LiDAR Quality Assessment Report

Juneau AK LiDAR

This task order is for planning, acquisition, processing, and derivative products of LiDAR data covering approximately 143 square miles of Alaska, including Juneau. The LiDAR data is to be collected at a nominal pulse spacing (NPS) of 1.0 meters.

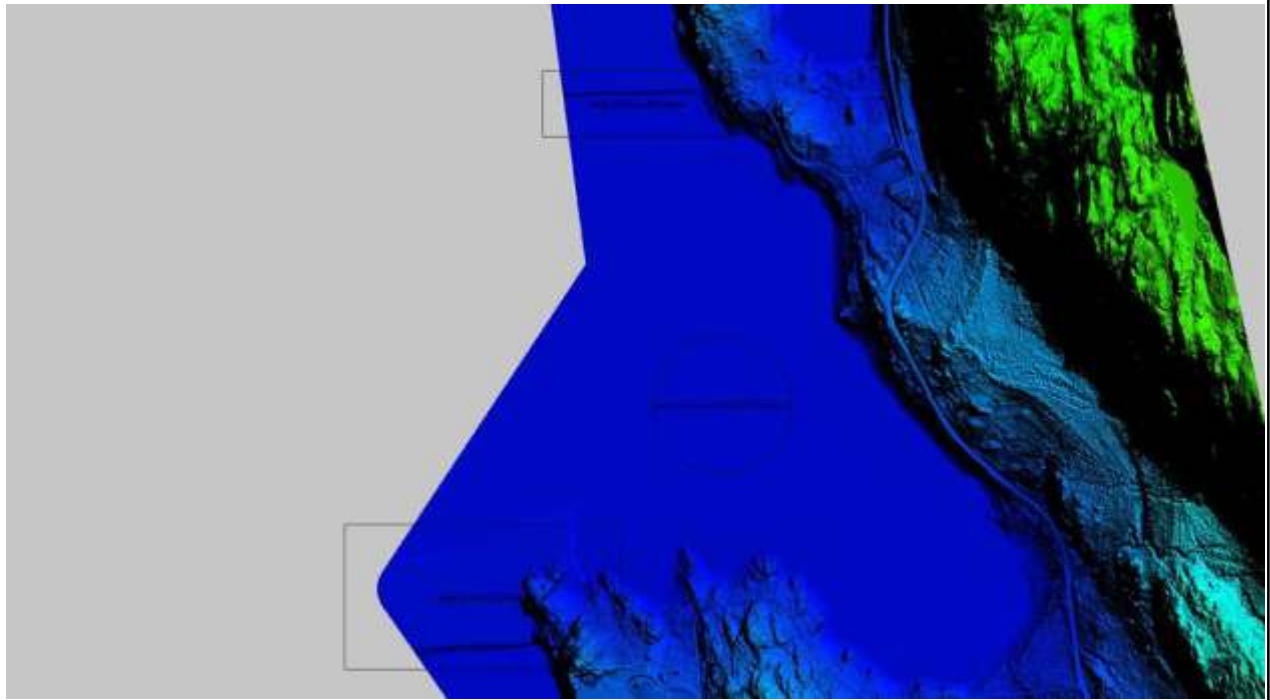
The Ocean Water Level varies throughout the project jumping in segments ranging from 1.2 to 4.1 M. It is not clear whether this is due to a datum issue or an issue with breaklines and/or leveling. *It was decided that this was acceptable for this project.

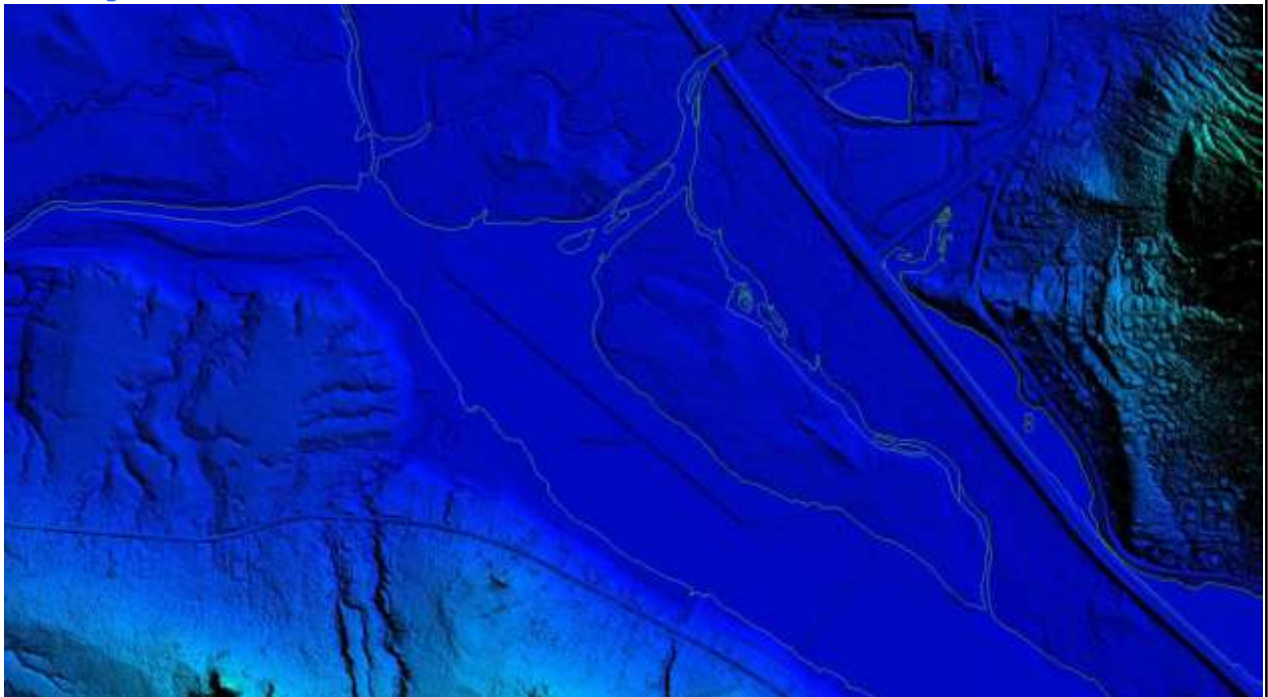
Some areas have very rigid water leveling and do not make sense given the underlying topography. *These areas were cleaned up in the redelivery.
